# 1990 - 1991 Corvette: Service Bulletin: 3-2 Coast Down Clunk

**Subject:** 3-2 COAST DOWN CLUNK (INSTALL SERVO SPRING)

**Model and Year:** 1990-91 CORVETTE WITH 4L60 AUTOMATIC TRANSMISSION

**Bulletin Number:** 91-372-7A - (06/27/1991)

Date of Production Change: (Figure 1)

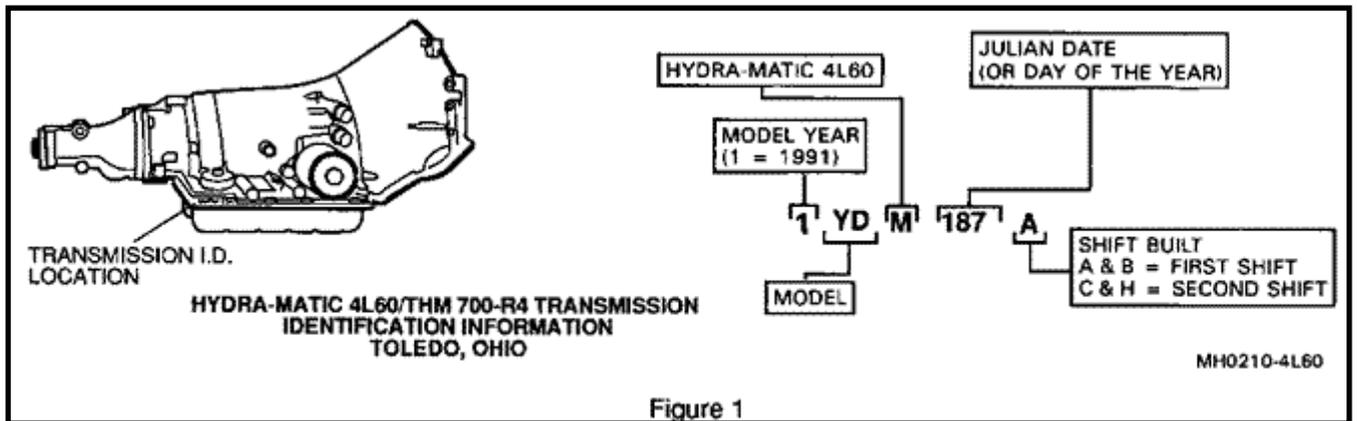
Beginning May 20, 1991 (Julian Date 140), all 1 YHM models of the HYDRAMATIC 4L60 were built using the new servo cushion assist spring and spacer plate.

Refer to Figure 2

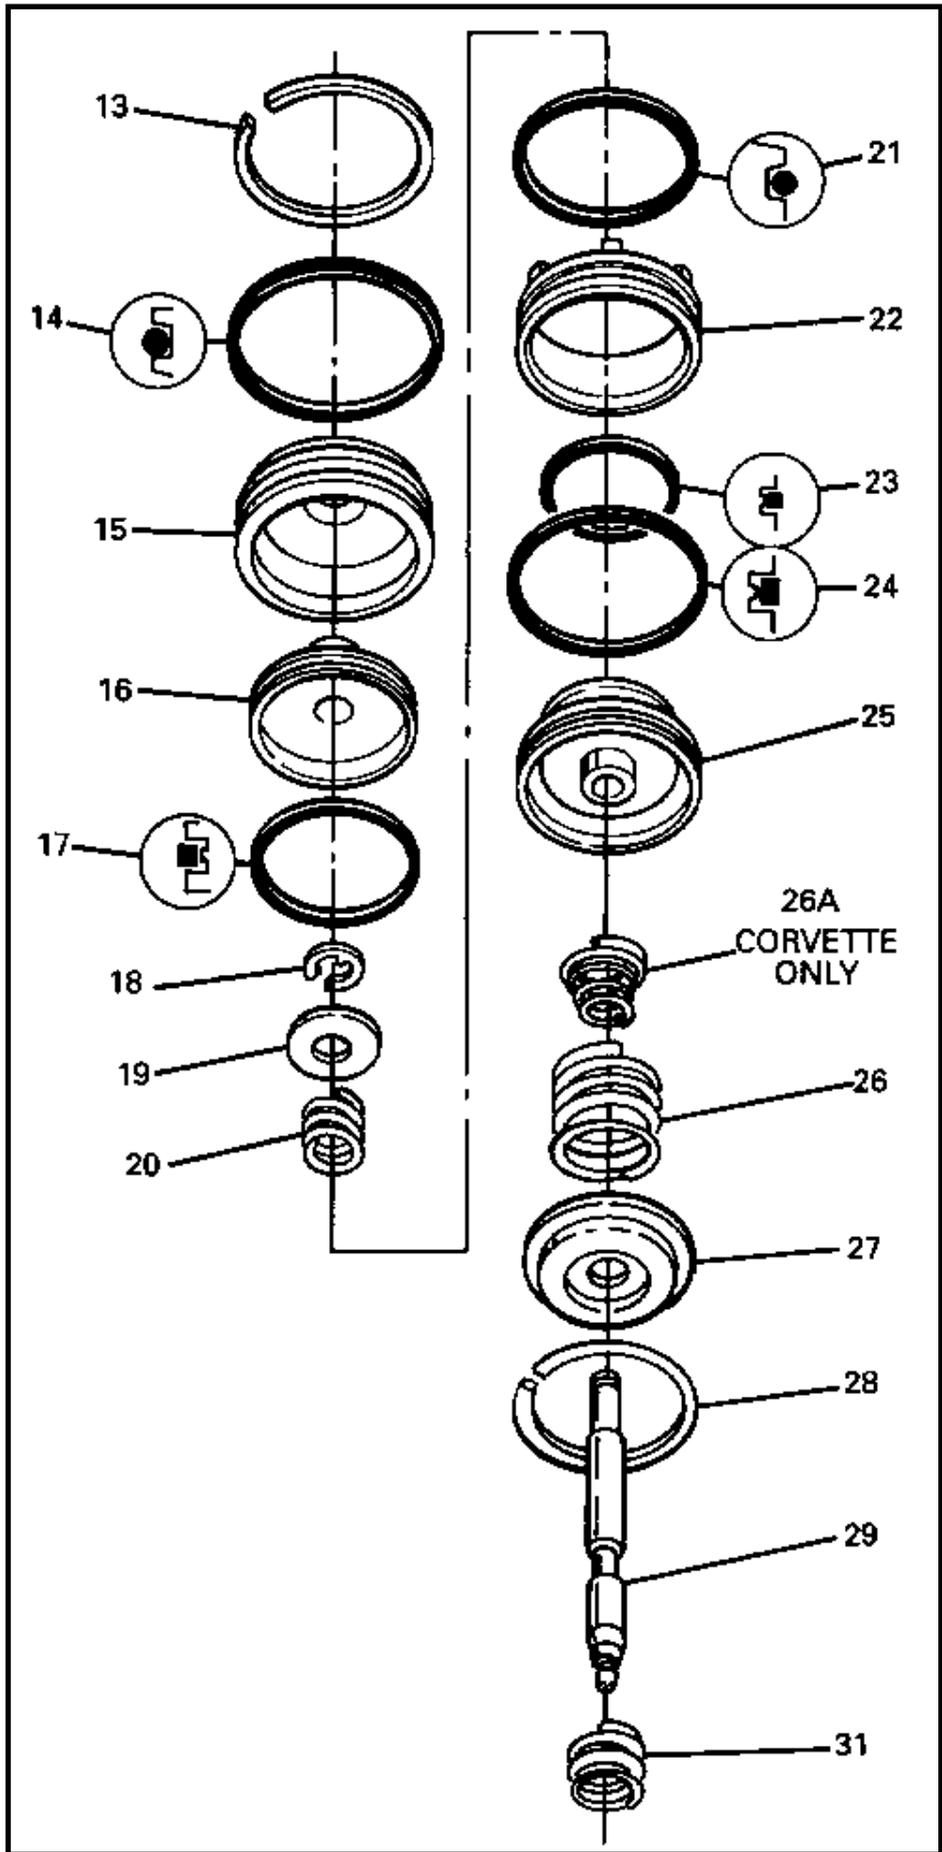
A new 2-4 servo cushion assist spring and spacer plate have been released to alleviate this condition. The new spring is a conical spring which nests inside the current 2-4 servo cushion spring. The new spacer plate has a modified third clutch exhaust orifice.

Install the new servo cushion assist spring inside the current servo cushion spring as shown in figure 2. Figure 2 shows the ONLY way the spring should be installed. Do not install the spring upside down. The new spring should not be used by itself.

Refer to the Automatic Transmission Unit Repair Section of the appropriate service manual for spacer plate removal and installation information. The 2-4 servo cushion assist spring is not shown in a service manual. Follow instructions for installing a 2-4 servo cushion spring, and add the servo cushion assist spring as shown in figure 2 of this bulletin.
